ADDENDUM NO. 1

2024 Transit Bus Acquisition for Three (3) 15 Passenger Low-Floor Buses
Project ID#: Transit 24-01

City of Casper
Casper, WY 82601

ADDENDUM DATE: April 3, 2024

**Exhibit A
10 Ambulatory Passengers and 2 Wheelchairs**

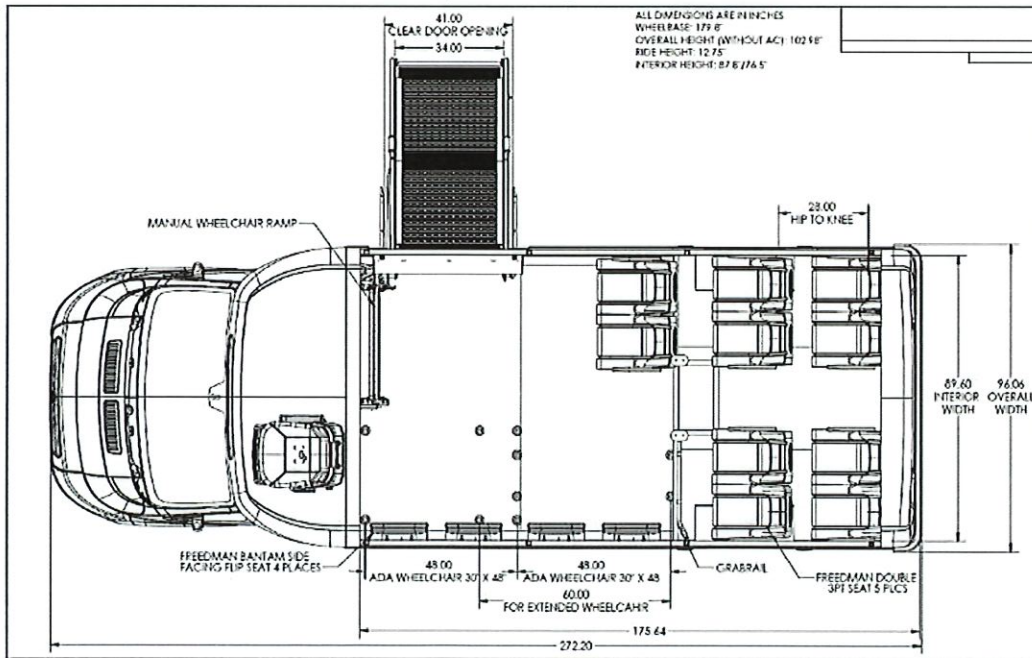
Please note that specification 9.1.1 has changed in order to meet ADA requirements as this bus will be over 22 feet in length. All three (3) buses will have seating for 10 ambulatory passengers and two (2) wheelchair positions with folding seats allowing for a maximum of 14 ambulatory seats. The following Exhibit A replaces Exhibit A on page 78 of the RFB.

18	6.10	Request "As-Built" Electrical Wiring Diagram to be provided through the Dealer Portal.	There must be a physical diagram on the back of the cover plate.
19	9.1.1	Seating on two (2) low-floor buses shall be provided for 12 10 ambulatory passengers and two (2) wheelchair positions with folding seats allowing for a maximum of 14 ambulatory seats.	The City is changing this spec in order to meet ADA requirements which requires vehicles over 22 feet in length to have enough securement locations and devices to secure two wheelchairs.
19	9.1.1	How many rows of seats are you needing? The traditional seating is 8+2 or 10+2 with the wheelchairs. I want to ensure that we can meet your needs.	The City is changing this spec in order to meet ADA requirements which requires vehicles over 22 feet in length to have enough securement locations and devices to secure two wheelchairs. Please see updated Exhibit A.
